**MISSISSIPPI DEPARTMENT OF TRANSPORTATION
TABLE OF CONTENTS**

PROJECT: BR-0054-01(056)/107817302 - Copiah

SECTION 904 -NOTICE TO BIDDERS NO. 1098

SUBJECT: Scope of Work

Detail of Waterway Signing

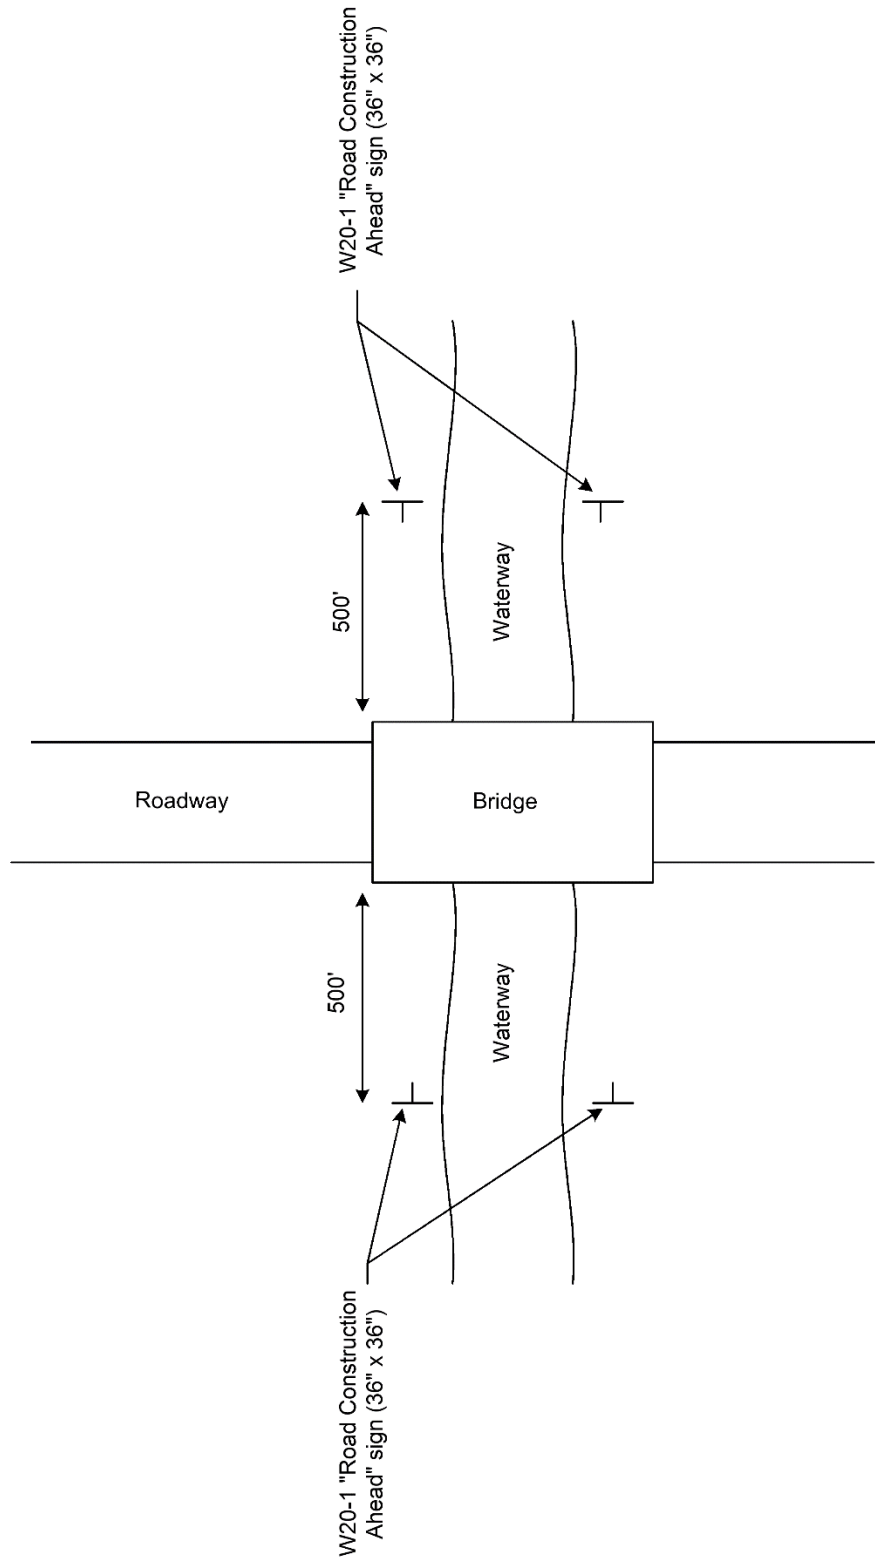
The Contractor shall erect and maintain construction signing and provide all signs and traffic handling devices necessary to safely maintain traffic around or through the work areas in accordance with the Traffic Control Plan. Payment shall be included in the price bid for Pay Item No. 618-A: Maintenance of Traffic. Special signing is required for the waterway as per the attached drawing.
